REMARKS

IN THE DRAWINGS

Objections to the Drawings

Figure 19

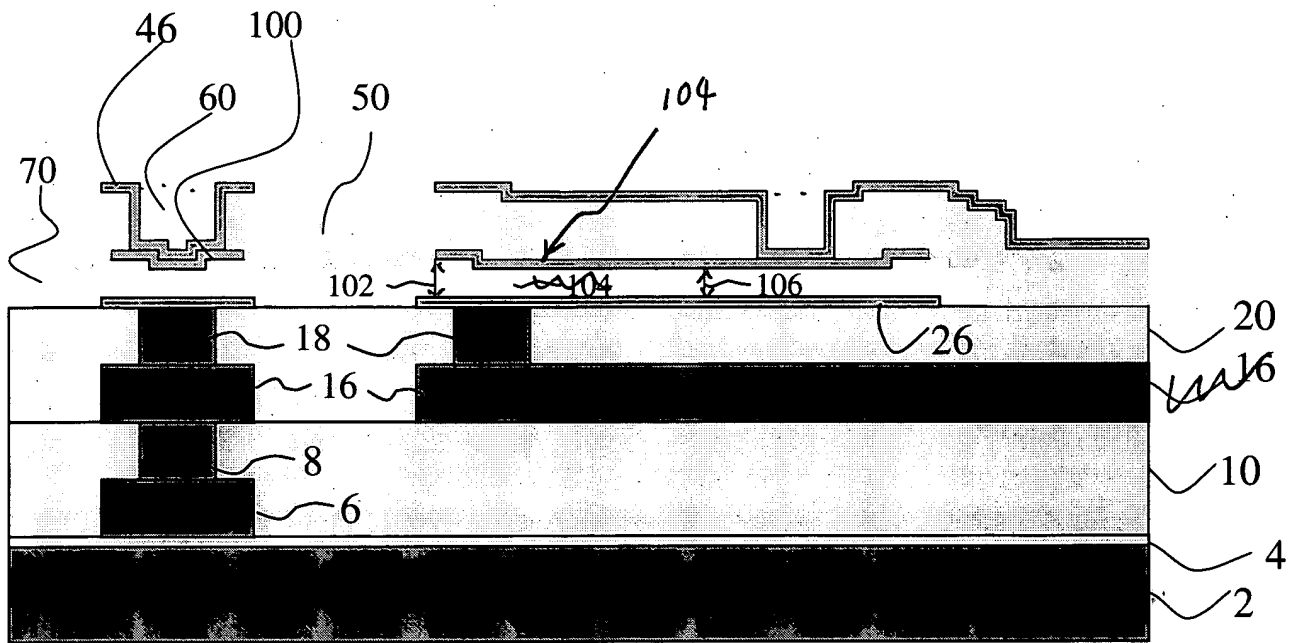
- first sacrificial layer 30 and second sacrificial layer 40 are more clearly delineated in the replacement drawings than in the original black and white copies of the original drawings;
- primary air gap 102 and secondary air gap 106 are more clearly illustrated;
- recessed electrode 104 is more clearly indicated by addition of arrow to associated lead line and by relocation of reference numeral 104; and
- cut-out 70, Via 60 and beam oxide 50 are more clearly differentiated.

Figure 19 of the present application shows an example of a recessed electrode 104 in Figure 19. It will be appreciated by one skilled in the art that the movable electrode 104 has at least two portions, distinguishable by the size of air gap 102 and 106 separating the portions from stationary electrode 26 (see also, Specification at page 9, lines 10-21).
